Village of Bayside
9075 N Regent Road
Architectural Review Committee Meeting
August 19, 2024
Village Board Room 5:00pm

ARCHITECTURAL REVIEW COMMITTEE AGENDA

Village of Bayside
9075 N Regent Road
Architectural Review Committee Meeting
August 5, 2024
Village Board Room 5:00pm

**ARCHITECTURAL REVIEW COMMITTEE
MEETING MINUTES**

AUGER ANCHOR DETAIL

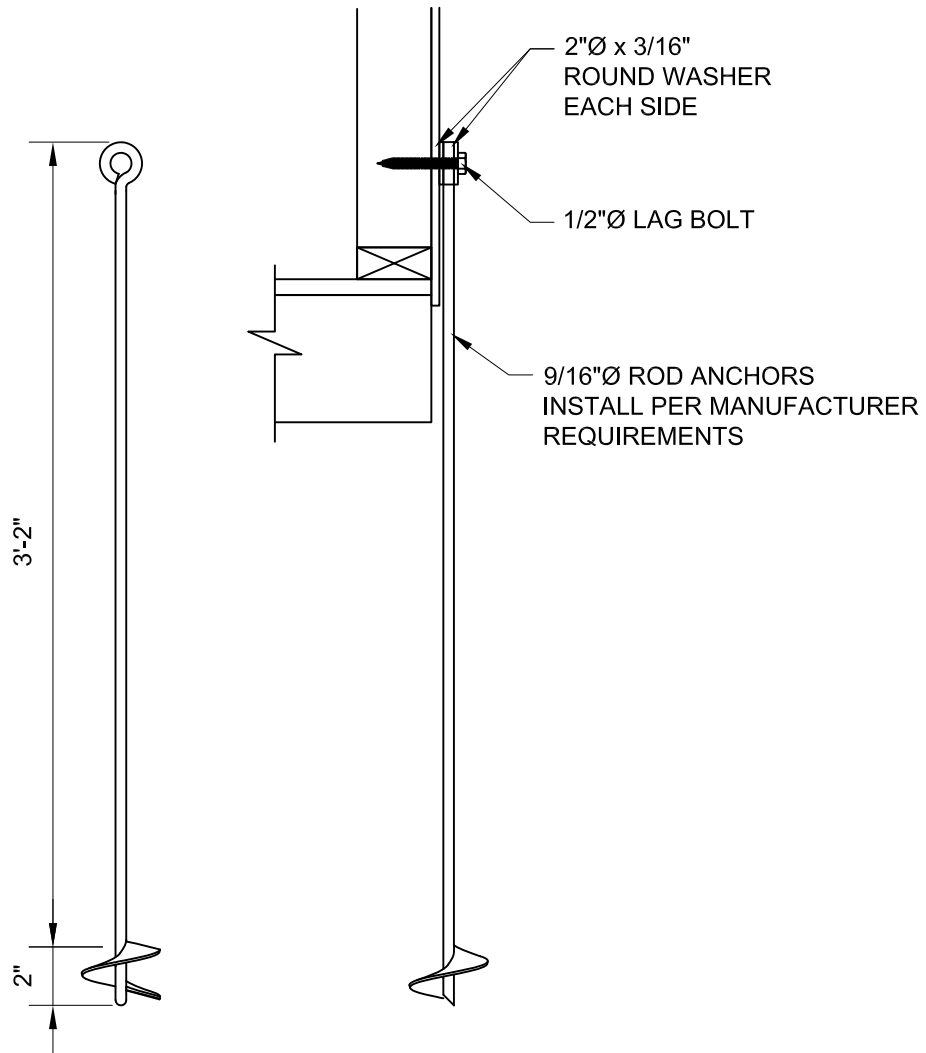
4. They submitted picture for the color of the shed to be considered.
5. No issues with this submittal
6. For permitting we will need an engineer's sign off for proper anchoring system

1 Proposed North Elevation - Day View
 SCALE: 1/8"=1'

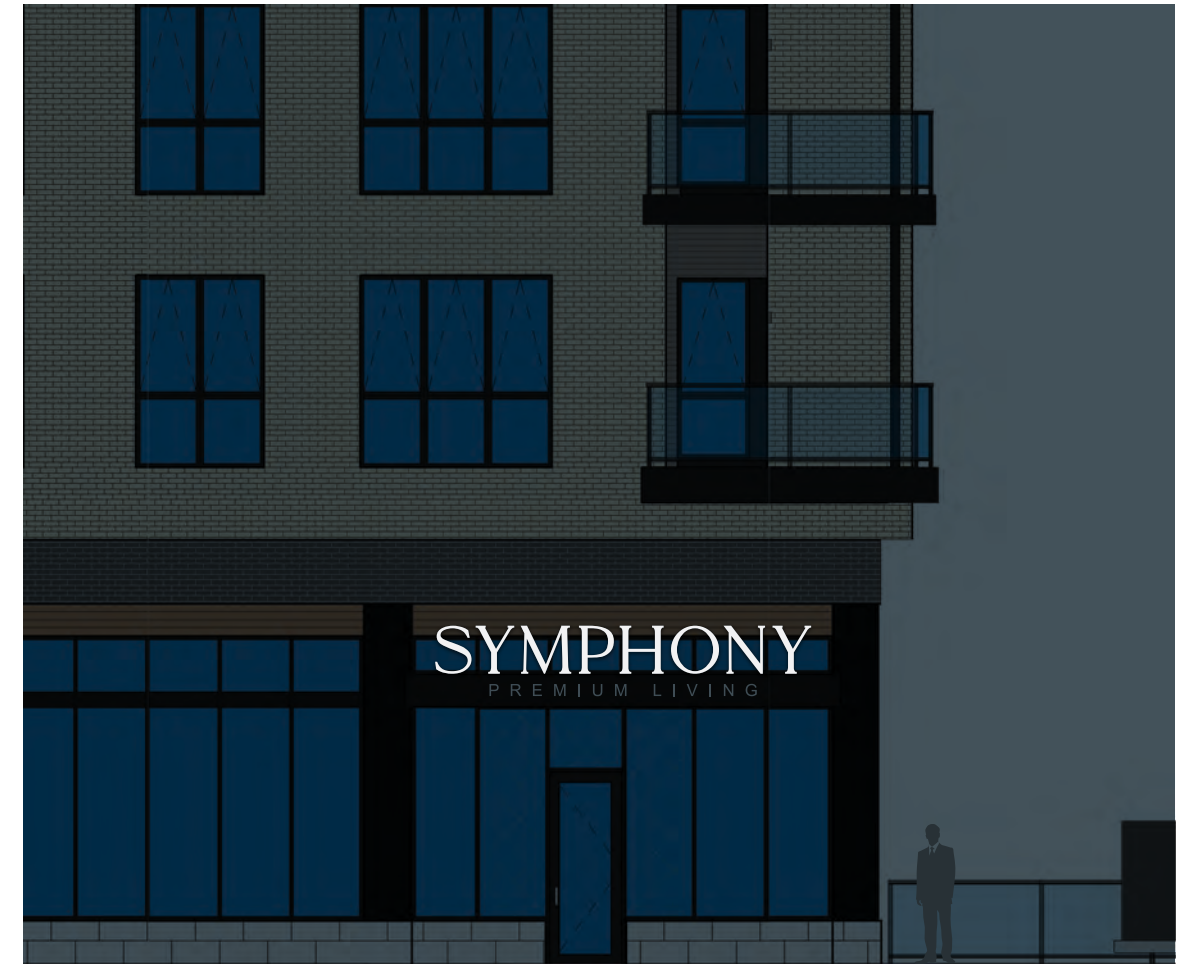
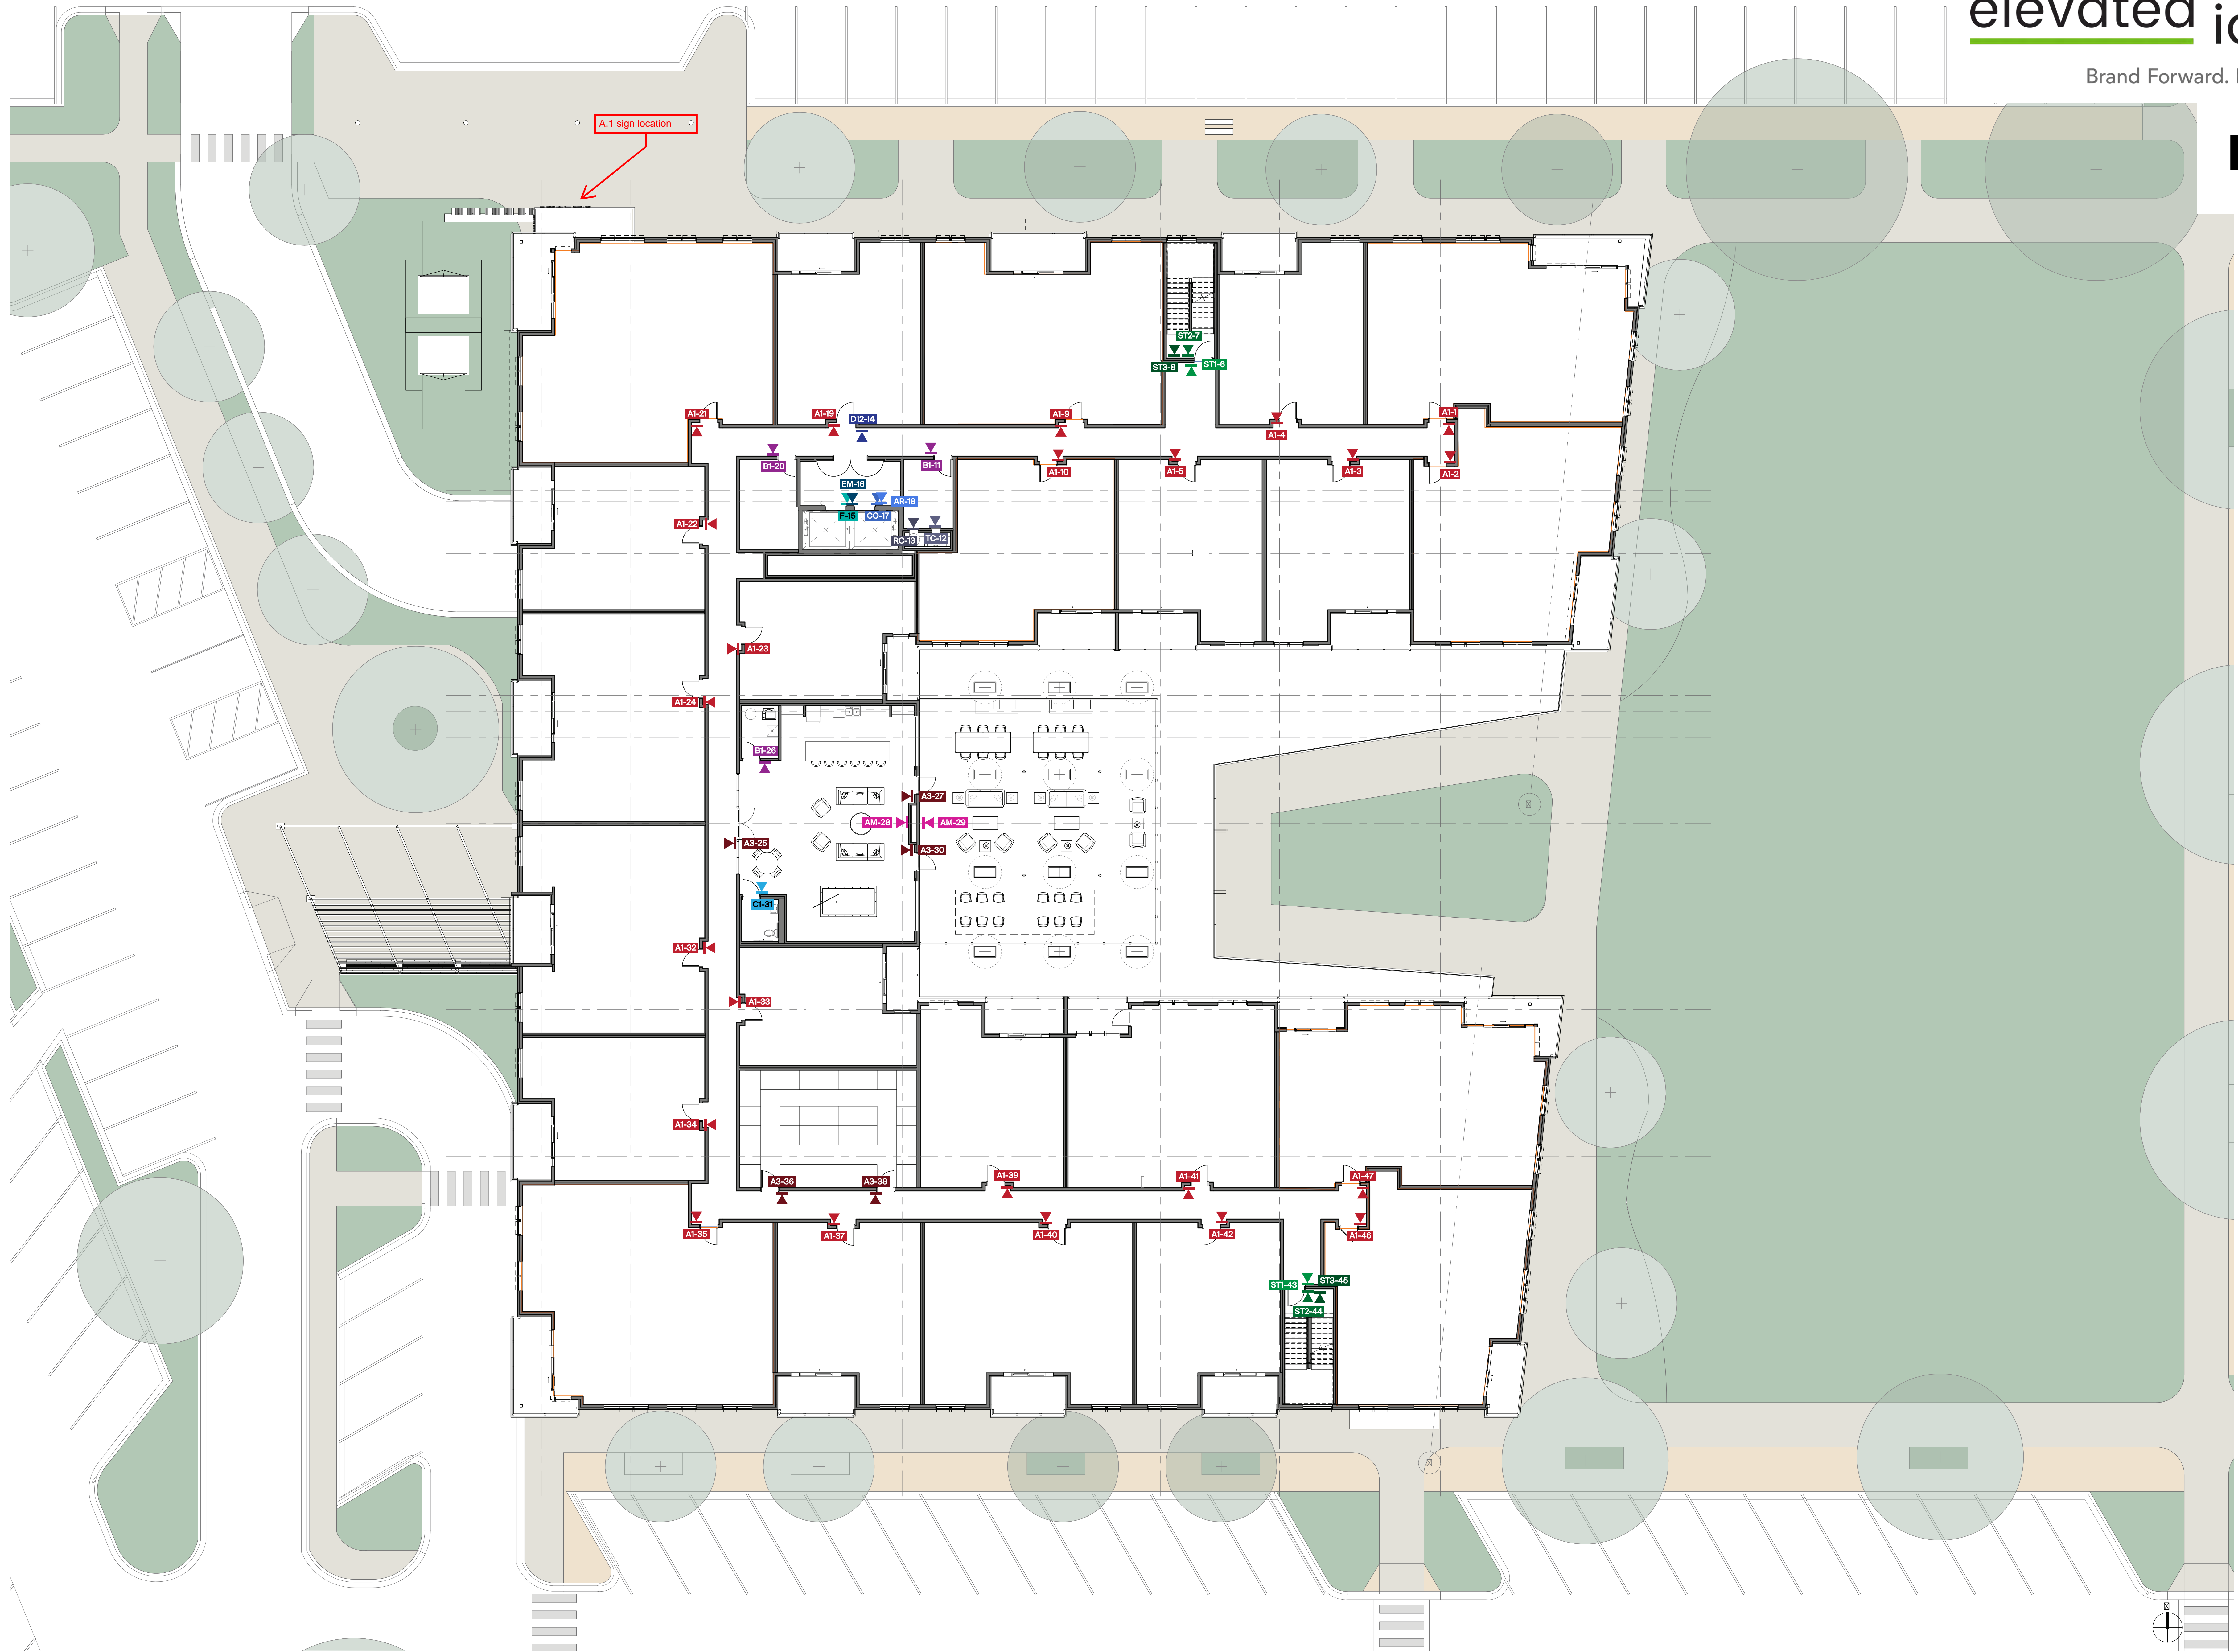
1. There is no issue with the canopy mounted sign.
2. The Board should reference any prior agreements for any specific stipulations.
3. The board always considers the aesthetics of the signs.
